UNITED STATES PATENT AND TRADEMARK OFFICE

APPLICATION NO.	FILING DATE	FIRST NAMED INVENTOR	ATTORNEY DOCKET NO.	CONFIRMATION NO.
18/698,915	04/05/2024	Tetsu MORISHIMA	228963	3163

Office Action Summary	Application No. 18/698,915	Applicant(s) MORISHIMA et al.	
	Examiner Eric K Wong	Art Unit 2874	AIA (First Inventor to File) Status Yes

DETAILED ACTION

Fig.11

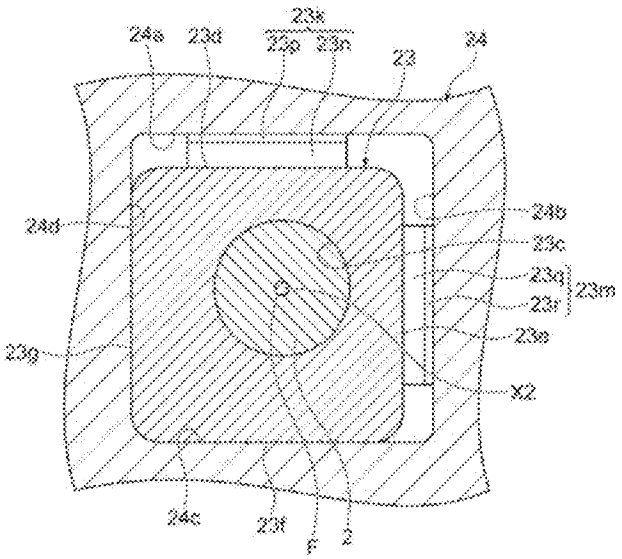
2. Applicant's arguments relate to newly clarified limitations regarding the reference surfaces and the planar surfaces that are parallel with a flange. These elements appear to be disclosed by Shimikawa in figures 5-6 and 11.

- an elastic member (5) that biases the flange toward the positioning portion,
- wherein the reference surface includes two contact parts (surfaces to the left and right of 23k in figure 11) provided apart from each other by a predetermined distance (the area bounded by spring 23k) and restricting a rotational direction of a flange as a result of the planar surface of the flange being brought into parallel contact with the planar surface of the inner wall surface with the planar surface of the flange contacting the two contact parts (when the flange is assembled with the provided spring cutout portion that resides within a channel that creates two contact points, the flange cannot rotate).

As to claim 2, the reference surface has a recessed part (23k) between the two flat reference parts.

As to claim 5, the outer shape of the flange is quadrangular (figure 11).

As to claim 6, an outer portion is curved (unlabeled corners are curved in figure 11).

As to claim 8, the "line" extending along the reference surface coincides with the flange (figure 11).

FIG. 4A

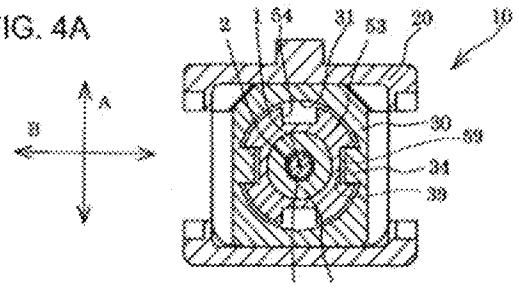
Inagaki discloses such a well known recessed surface with projections (figure 4A).

It would have been obvious to one having ordinary skill in the art to add recessed portions with corresponding projections as taught by Inagaki to lock a flange's spring in Shimikawa in place to prevent misalignment.
